## Technical Memorandum #3

**RE:** Highway 286/Dave Ward Dr. – 90% Review

**DT:** May 13, 2015

Candlestick style lane delineators with ultimate sign placement

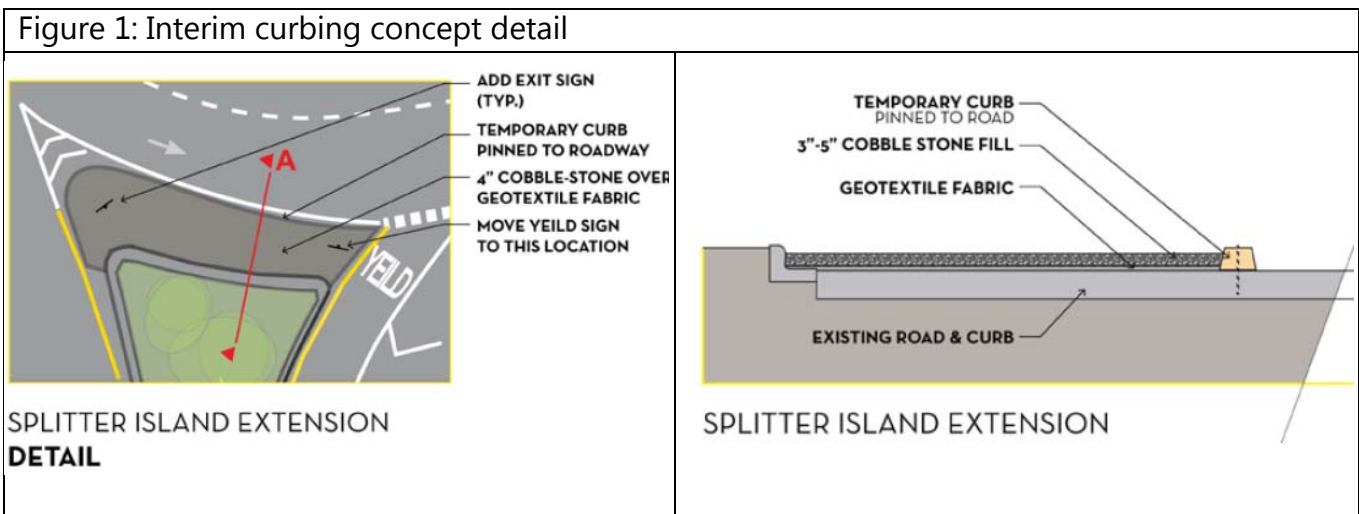
The 90% interim design utilizes candlestick style delineators (see example to right) to establish the “interim” geometry. This proposed interim design application produces less than optimal sign location placements.

For example, Yield signs and Exit signs, along with other directional signs

placed in the ultimate locations, are not correctly placed for optimal viewing, as they are located further from drivers’ view.

Figure 2: Circulatory roadway line types

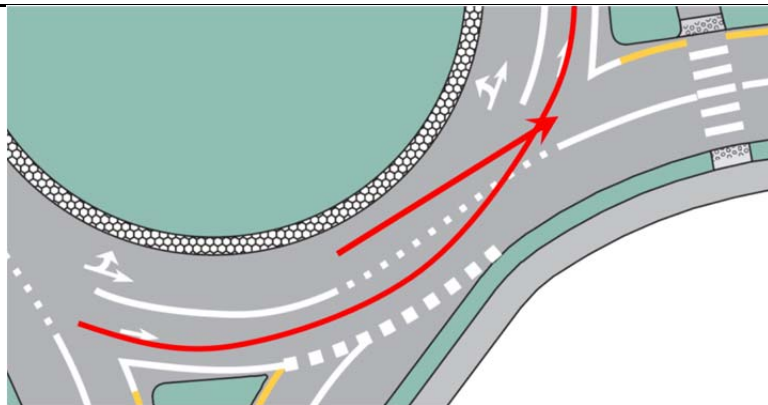
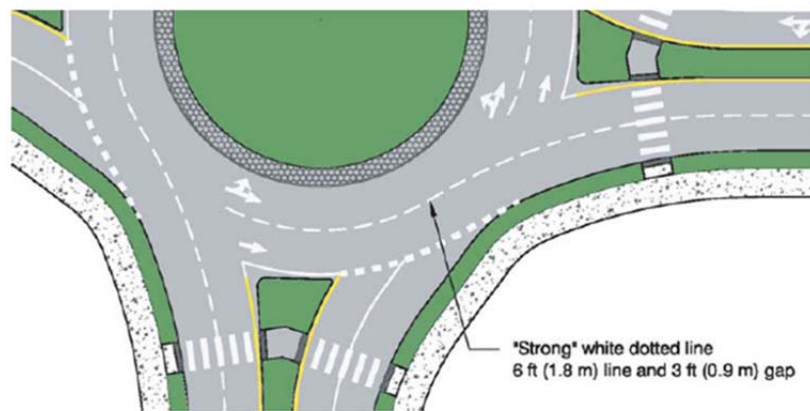
- The proposed differing line types and widths within the circulatory roadway markings through to the exits has been shown to reduce driver comprehension, leading to lane discipline related crashes.

Inconsistent circulatory line type (solid followed by skips) creates lane discipline crashes.

Consistent line type provides correct information to driver to stay in lane.

Figure 4: Central island landscaping concept cross-section

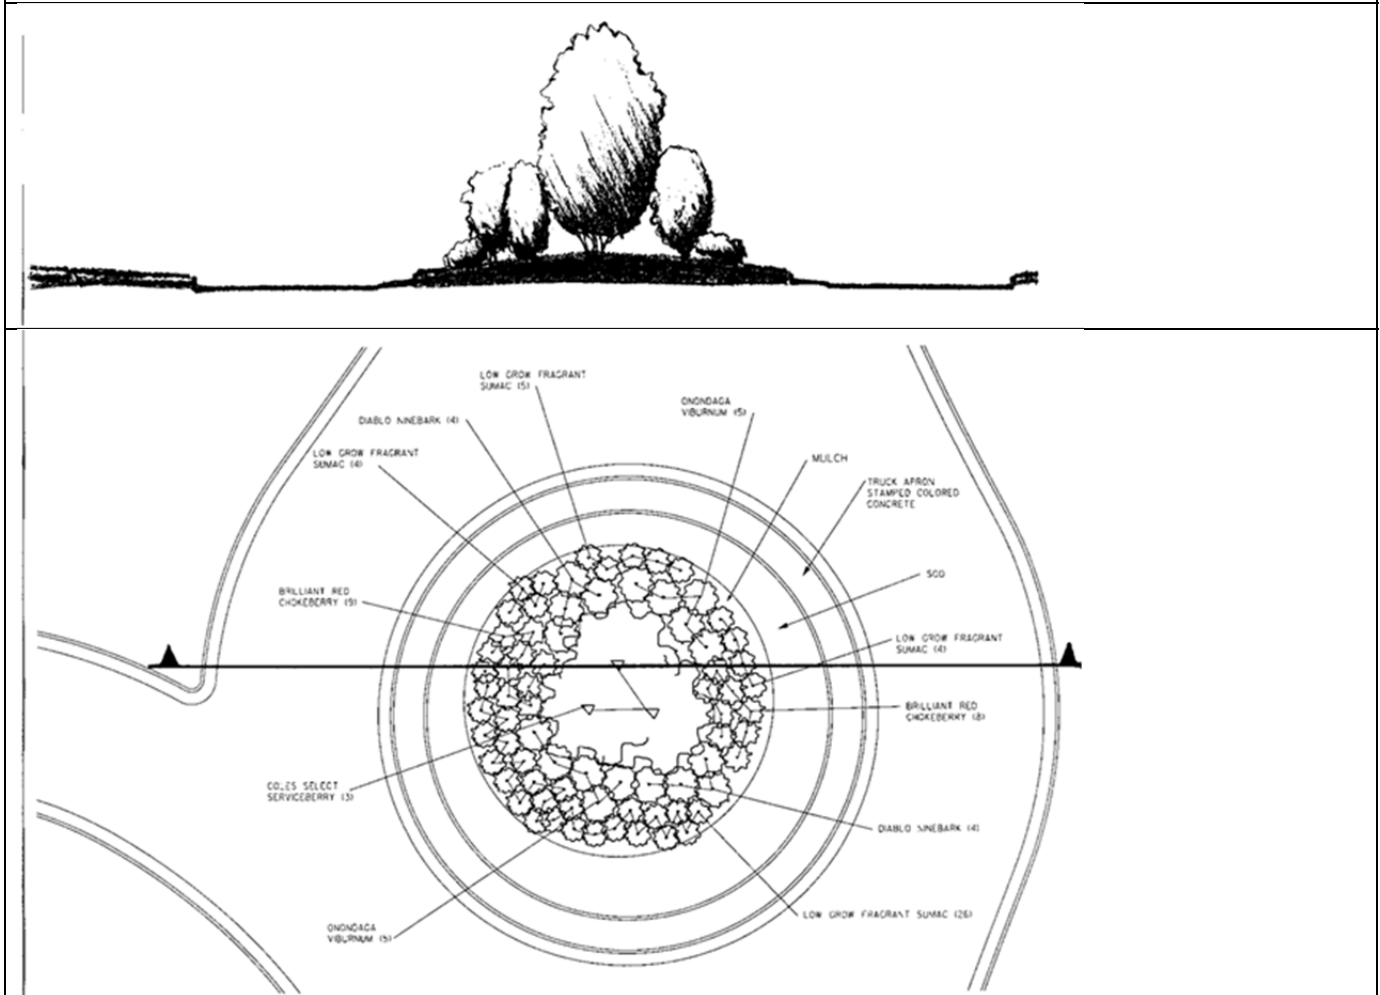
Central island landscaping: According to NCHRP 672, central island landscaping *should be strategically located to limit the amount of excess sight distance to help encourage slow speeds*. Central island concept landscaping recommendations are shown below in Figure 4. Key to this design application is utilizing taller growth plants in the center and tapering to lower growth plants around the perimeter. The landscape plan should incorporate appropriate species of plants and be planted so as to reduce maintenance needs.

MTJ REVIEW - GEOMETRIC/PAVEMENT RECOMMENDATIONS  
 5.11.2105

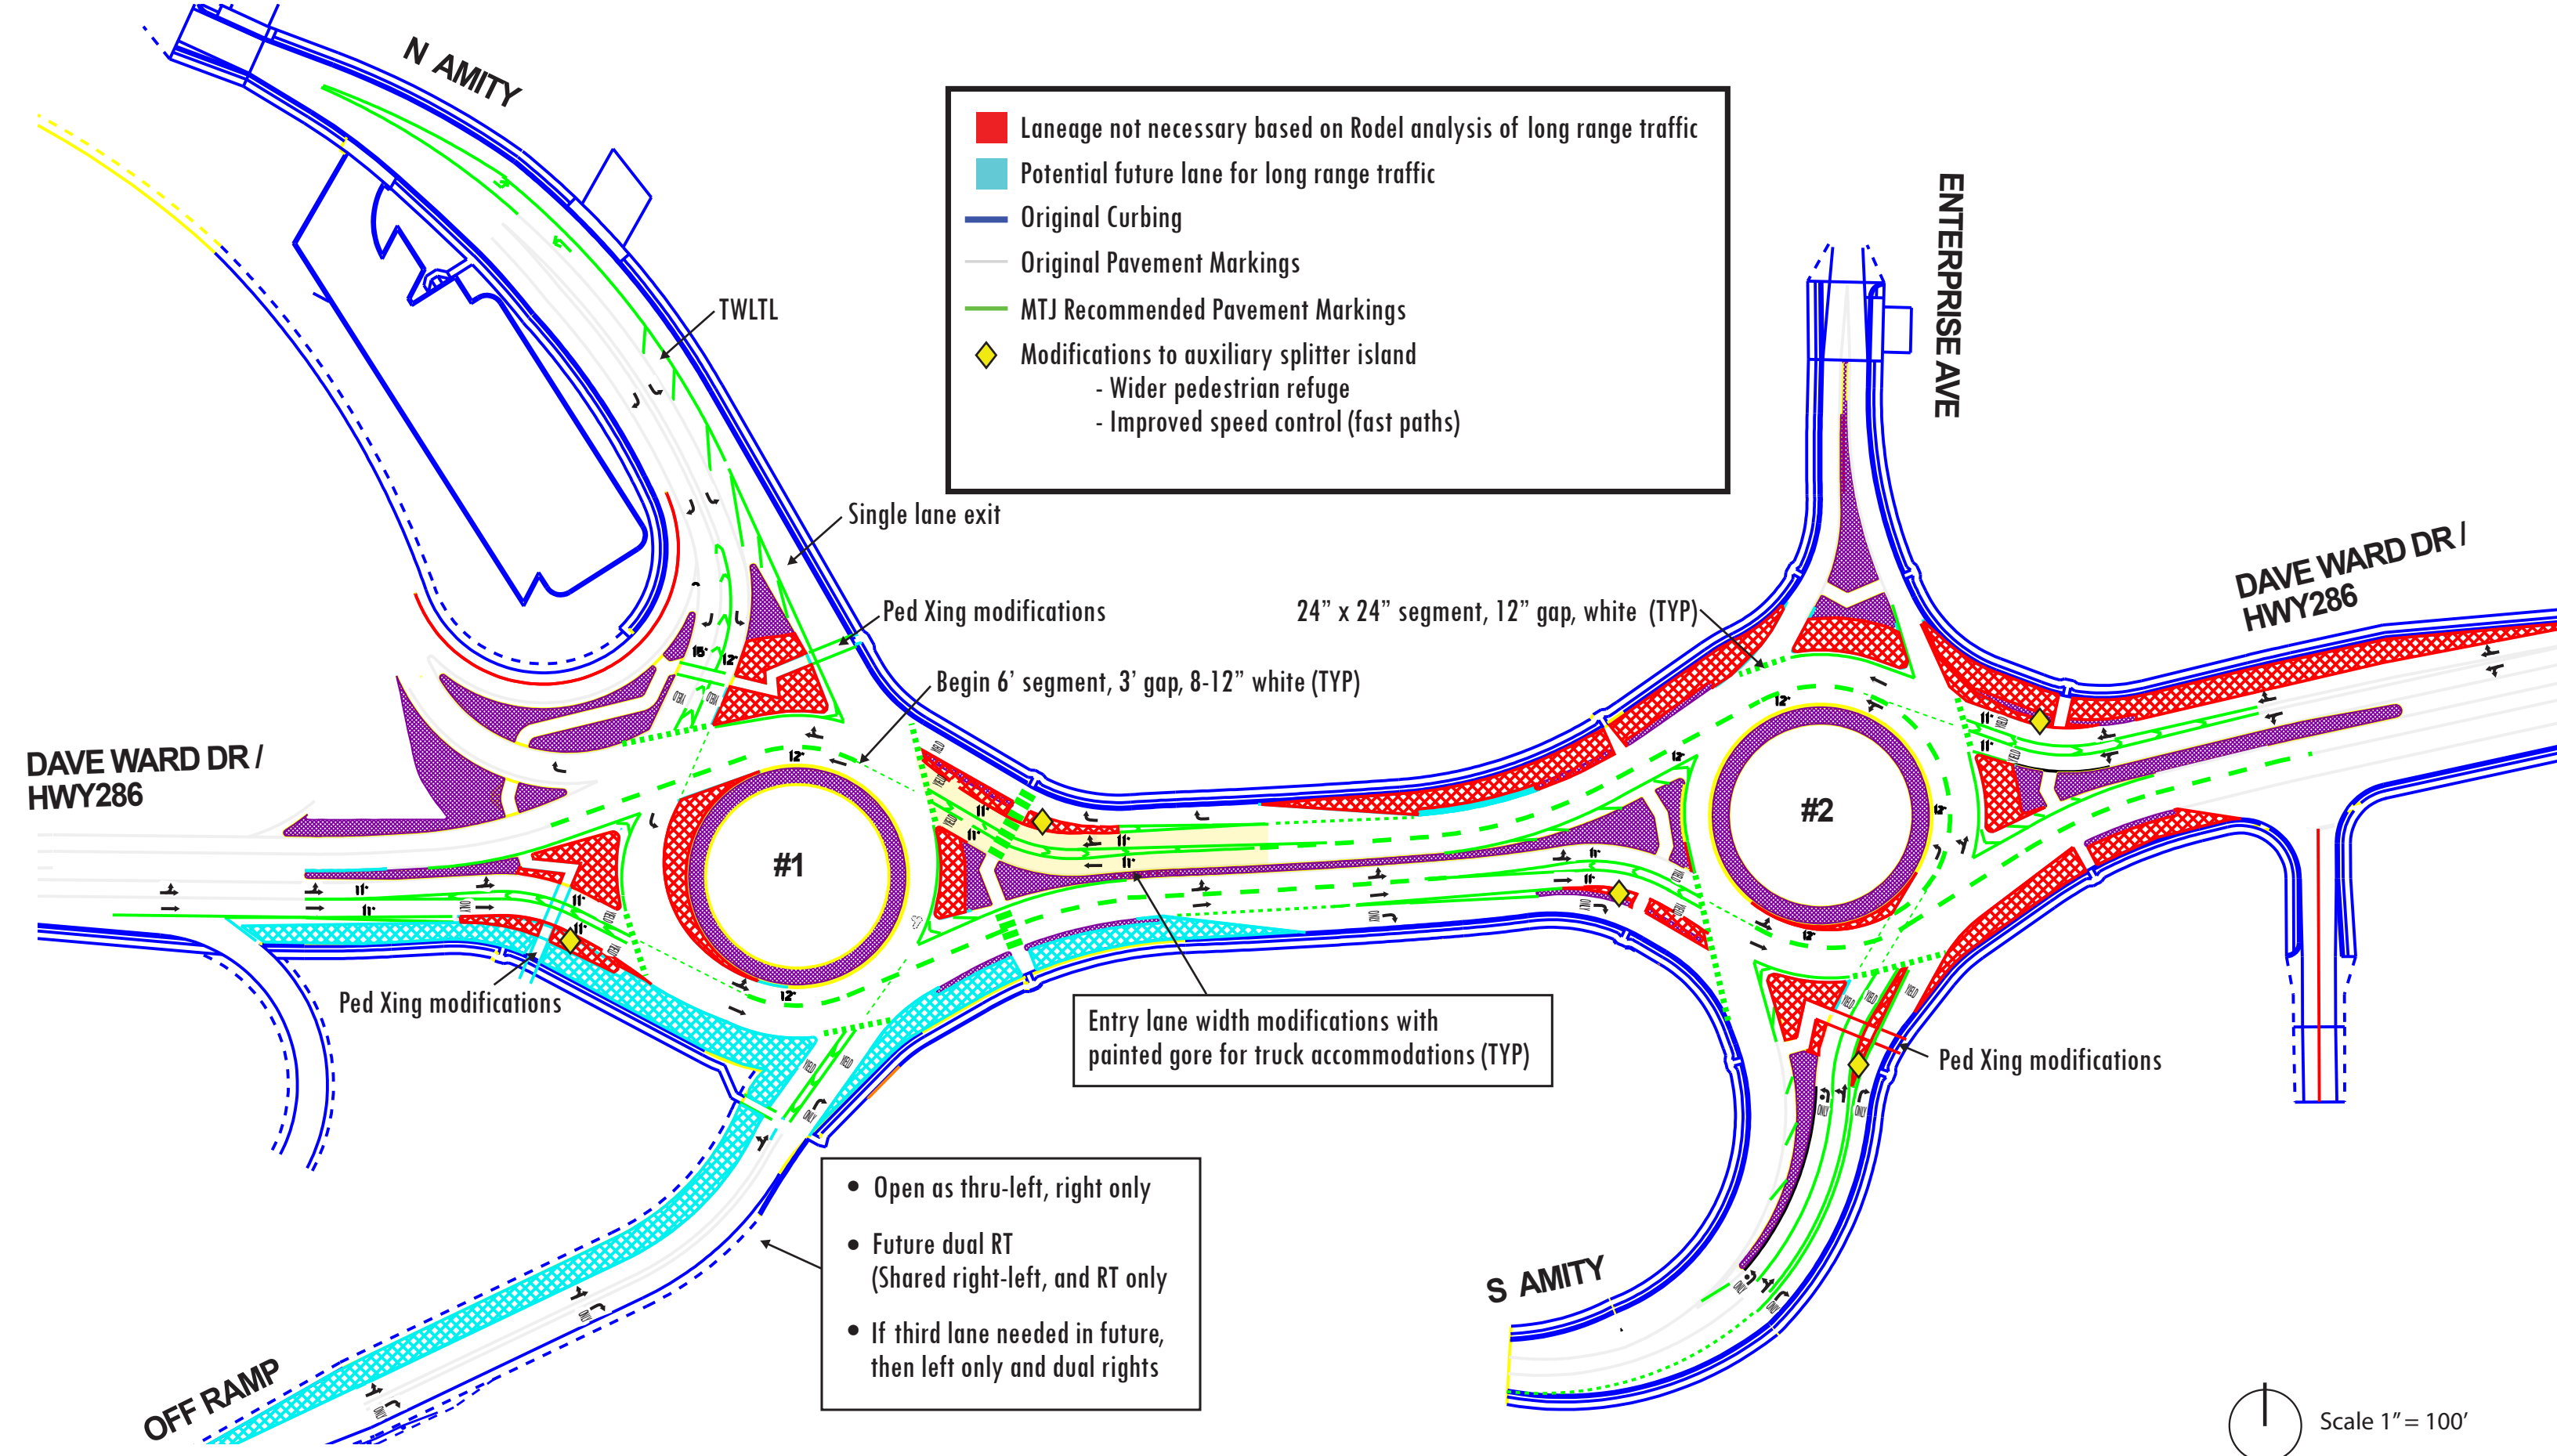
■ Laneage not necessary based on Rodel analysis of long range traffic  
■ Potential future lane for long range traffic  
— Original Curbing  
— Original Pavement Markings  
— MTJ Recommended Pavement Markings  
◆ Modifications to auxiliary splitter island  
 - Wider pedestrian refuge  
 - Improved speed control (fast paths)

- Open as thru-left, right only
- Future dual RT (Shared right-left, and RT only)
- If third lane needed in future, then left only and dual rights

Modified Advanced Diagrammatical

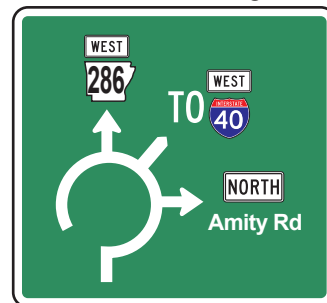
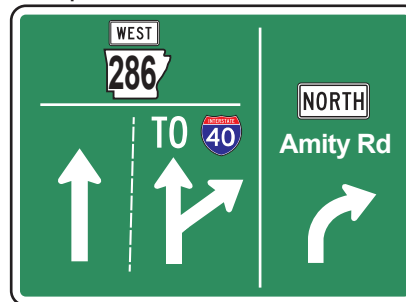
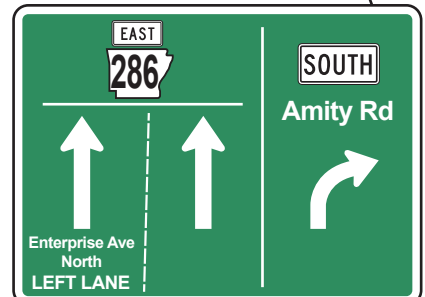
Our review recommends modifications to the advanced directional signing to improve driver lane choice for desired destination. These directional signing recommendations will provide improved messaging, way-finding, driver comfort and safety. Please see these advanced directional sign recommendations shown in the attached signing plan graphics.

MTJ REVIEW - FAST PATHS  
5.11.2105

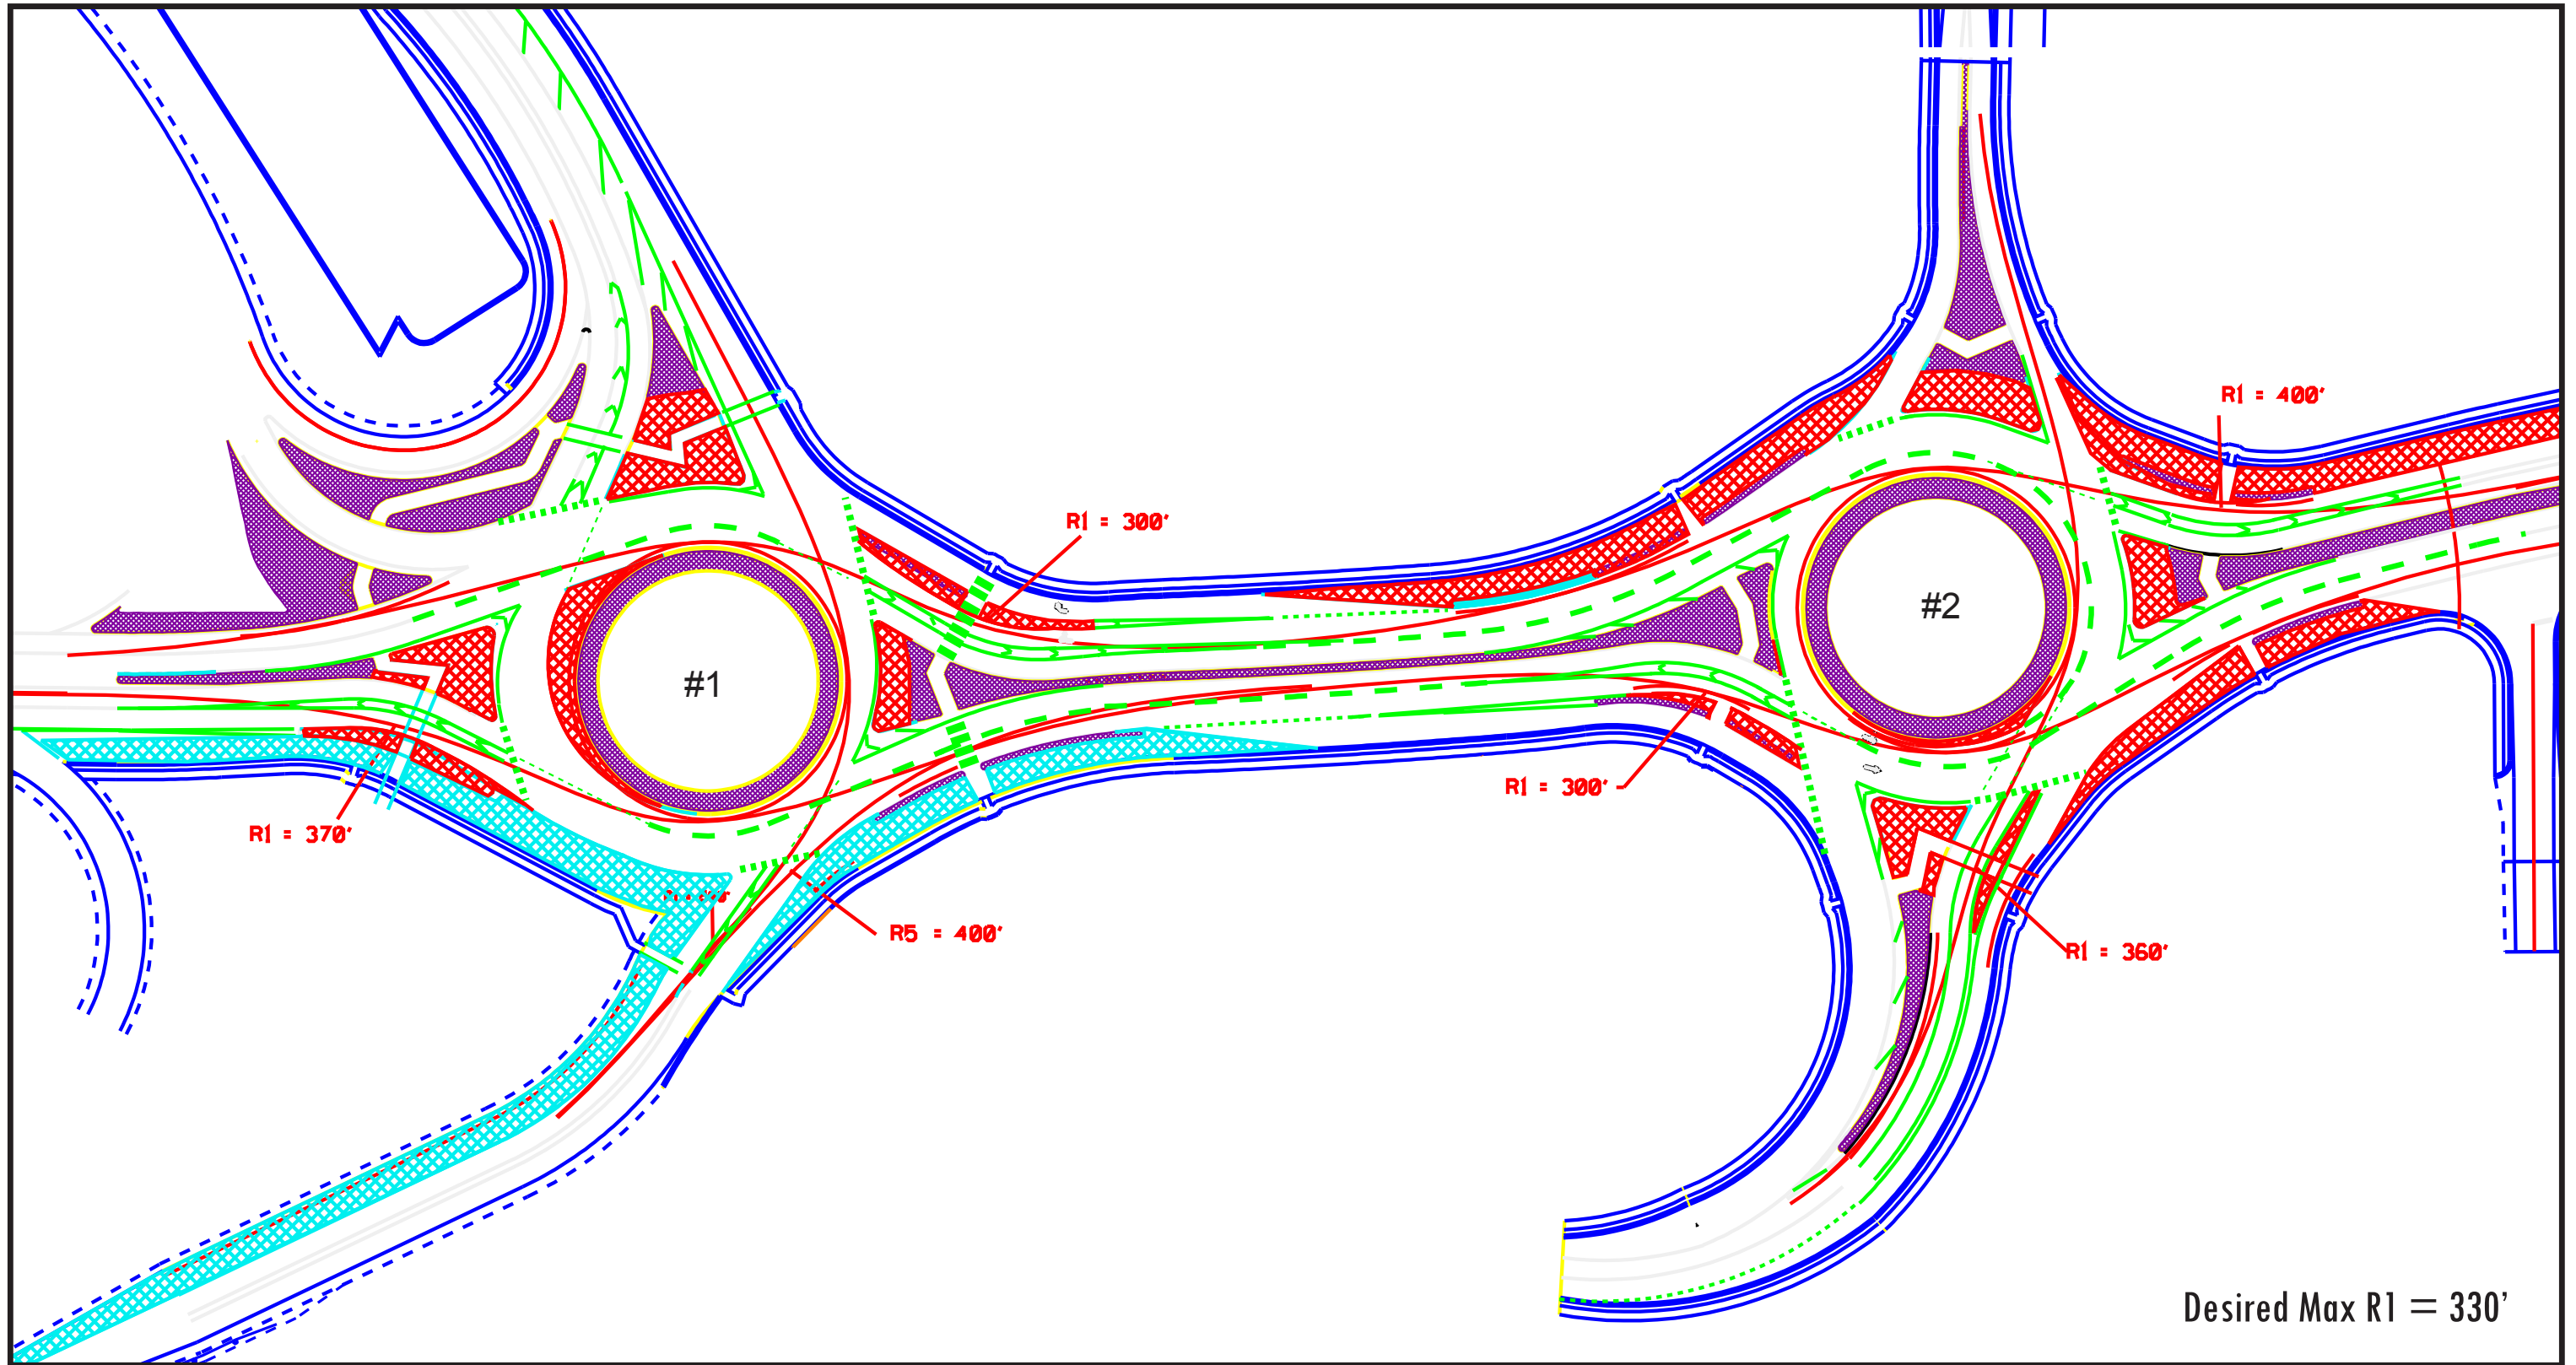
The recommended reconfigured entries utilize 11' lanes and a widened painted gore for large truck accommodation and removes the raised vane islands. This redesign is consistent with current state-of-the-practice and provides improved truck accommodations, slower fast path radii, and reduces concerns with loss-of-control crashes for motorcycles. These proposed modifications improve speed control without the use of the narrow vane islands, allowing for substantial conformance to fast path criteria.
